VERIFICATION REPORT

5th Verification of
**Xiaogushan Hydropower Project in
People's Republic of China**

CDM Reference No. 0378

Report No. GR11W0003D

Figure 2: Water flow of Heihe River and generation

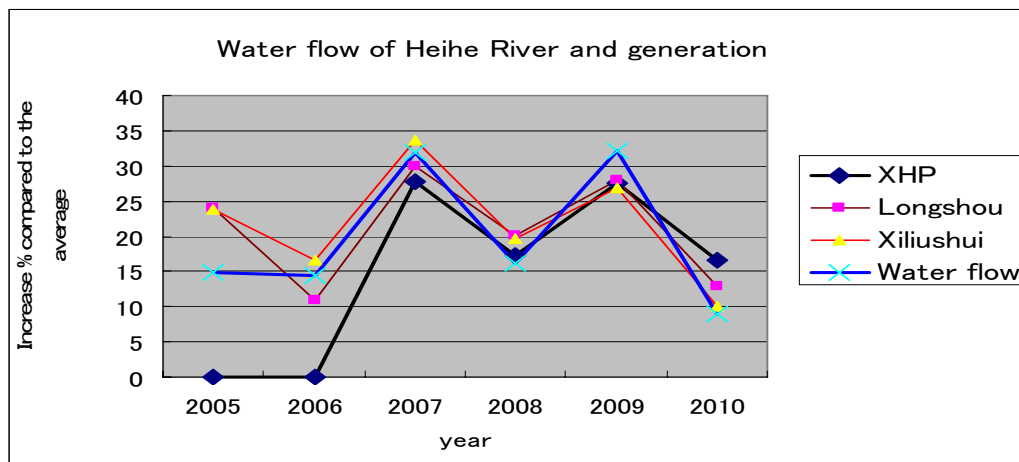
- (1) Is there any case that XHC imported the electricity from the grid?
- (2) Invoice of XHC to PGTC and Evidences of EGaux for the line 1117 & 1118 and EGplant are to be provided.
- (3) The electricity generation increase in 2010 is 16.6% of the PDD against the river water flow rate increase of 8.8%. On the other hand, the electricity generation increase in 2009 is 27.6% against the river water flow rate increase of 32.1% and these data are nearly proportionate.

According to hydrological statistic of Yingluo Gorge station in Gansu Province, the annual runoff monitored at Heihe Yingluo Gorge in 2010 was 1725 million m³. Average annual runoff during the past 67 years from 1944 to 2010 at the same point is 1586 million m³. The ratio between the water flow rate in 2010 and the historical average flow rate (67 years) is $1725/1586 = 1.088$, which means the flow of the year 2010 is 8.8% greater than the average value of the last 67 years and this explains the 16.6% increase in the annual electrical supply to the grid in year 2010.

Further, the power generation data (2005-2010) for the two other hydropower plants (Longshou and Xiliushui), which are located in the downstream of Heihe river shows a very consistent pattern with the generation data of the Xiaogushan power plant and the hydrological statistic of the Yingluo Gorge, which is illustrated in Figure 2 below.(/17/) This proves that the increase in annual electrical supply to the grid and power generation is due to the increased water flow.

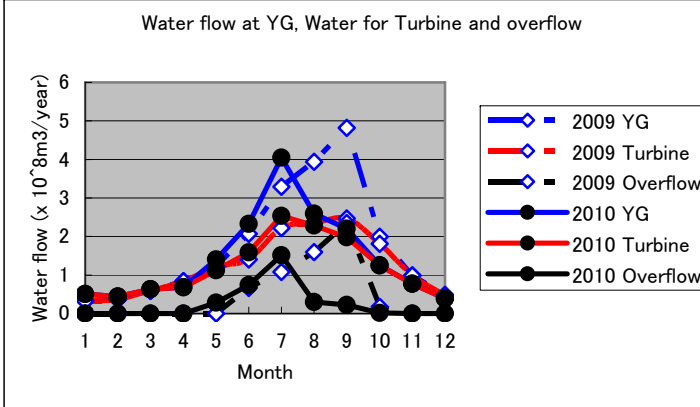
Draft report clarifications and forward action request by audit team	Ref. to checklist Table I, II – 1 to 3	Summary of project owner response	Audit team conclusion
<p>(3) The description about “the date of last calibration” in the monitoring report is confusing. Please clearly show that the calibration of each meter is valid throughout the year of 2010.</p> <p>(4) According to the calibration report of ESplant, the date of last calibration is 3/09/2008 for all 3 ESplant meters. Please confirm the date of the monitoring report.</p> <p>Clarification Request 3 (Table 1, 3.1)</p> <p>(1) Is there any case that XHC imported the electricity from the grid?</p> <p>(2) Invoice of XHC to PGTC and Evidences of EGaux for the line 1117 & 1118 and EGplant are to be provided.</p> <p>(3) The electricity generation increase in 2010 is 16.6% of the PDD against the river water flow rate increase of 8.8%. On the other hand, the electricity generation increase in 2009 is 27.6% against the river water flow rate increase of 32.1% and these data are nearly proportional.</p> <p>The electricity increase is considerably bigger than the increase of the flow rate increase in 2010 and not proportional. The reason of this result and the difference between 2009 and 2010 are to be explained.</p>	<p>II-3.1</p>	<p>the test bed calibration (once per 5 years).</p> <p>(3) The description of the monitoring report was revised.</p> <p>(4) The description of the monitoring report was revised to 3/09/2008 for all 3 ESplant meters based on the calibration report.</p> <p>CL.3</p> <p>(1) There is no case that XHC imported electricity from the PGTC in 2010.</p> <p>(2) Following data were provided.</p> <p>EGy: Power purchase settlement notice, Invoice of XHC to PGTC Record of EGy meter reading by XHC (monthly data for the line of 1117, 1118 & total) (/4/)</p> <p>EGplant: Record of XHC (monthly data and daily data for each generator) (/4/)</p> <p>ESplant: Record of XHC (monthly data) (/5/)</p> <p>EGaux: Record of XHC (monthly data for the line of 1117, 1118 & total) (/4/)</p> <p>(3) The reason of the generation increase of 16.6% against the river water flow rate increase of 8.8% is explained below.</p> <p>(3-1) The river water flow rate at Yingluo Gorge and water for generation for Xiaogushan hydropower plant:</p> <p>(i) The river water flow rate increased by 8.8% compared with the long time statistics of flow rate monitored at Yingluo Gorge. (/12a/) The water flow rate</p>	<p>(3), (4) OK</p> <p>The verification team confirmed by the calibration records of each meter and the response to CL 2 that the calibration of each meter was conducted in accordance with the 3rd revision of monitoring plan. (/1/)(/33/)</p> <p>The verification team confirmed that the monitoring report was revised properly.</p> <p>CL.3</p> <p>(1) OK, The verification team confirmed in PGTC provincial office and XHC that there is no case that XHC imported electricity from the PGTC in 2010.</p> <p>(2) OK, The verification team confirmed that the data of EGy, EGplant, ESplant and EGaux in the Monitoring report are identical with their evidences. (/2/, /3/, /4/,/5/)</p> <p>In addition to that, the verification team visited PGTC provincial office in Lanzhou and confirmed that the EGy data of above Power purchase settlement notices are identical with the original data of PGTC. (/51/)</p> <p>(3) OK, The generation increase of 16.6% against the river water flow rate increase of 8.8% in 2010 is due to the increase of water flow in the Heihe river and favorable water flow condition available for the Xiaogushan hydropower plant in 2010. Figure 4 shows water flow at Yingluo Gorge, water flow for turbine (used for electricity generation) and overflow in 2009 & 2010.</p>

Draft report clarifications and forward action request by audit team	Ref. to checklist Table I, II – 1 to 3	Summary of project owner response	Audit team conclusion
		<p>statistics used for FSR and also used for the estimate of electricity generation in the PDD is the data at Yingluo Gorge.</p> <p>The Yingluo Gorge is in the Heihe river and located at approximately 30km down-stream of the Xiaogushan hydropower plant and several branch rivers are flowing into the main stram of Heihe river between the Xiaogushan hydropower plant and the Gorge as shown in fig.3 below.</p>	<p>Fig.4: Water flow at Yingluo Gorge (YG), Water for turbine and overflow in 2009 & 2010</p>  <p>Water flow at YG, Water for Turbine and overflow</p> <p>As indicated in figure 4 and table 3 of PP response, the over flow ([Water flow rate at Yingluo Gorge] – [Water for XHP generation]) in 2010 is 3.1×10^8 m³, which is 18% of the water flow rate at Yingluo gorge. On the other hand, the over flow in 2009 is 5.9×10^8 m³ which is 28% of the water flow rate at Yingluo Gorge. This shows that the overflow in 2010 is far smaller than that of 2009.</p> <p>Above explanation and figure 4 indicate that the river water flow condition at Xiaogushan hydropower plant in 2010 is considerably favorable and well utilized compared to 2009. The verification team considered that the response of PP is reasonable.</p>

Fig.3: Location of Hydropower station and Yingluo Gorge (flow rate monitoring point)

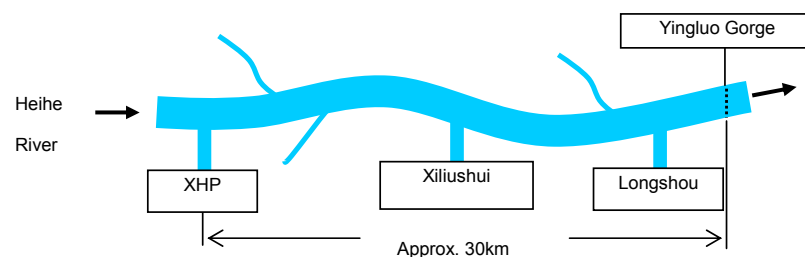
<p>The water flow rate at the Xiaogushan hydropower plant is not the same as the water flow rate at Yingluo Gorge.</p> <p>(ii) The river water overflows the dam especially in high-water season. Such portion of over-flowed water is not used for electricity generation. Portion of such water not used for electricity generation changes</p>
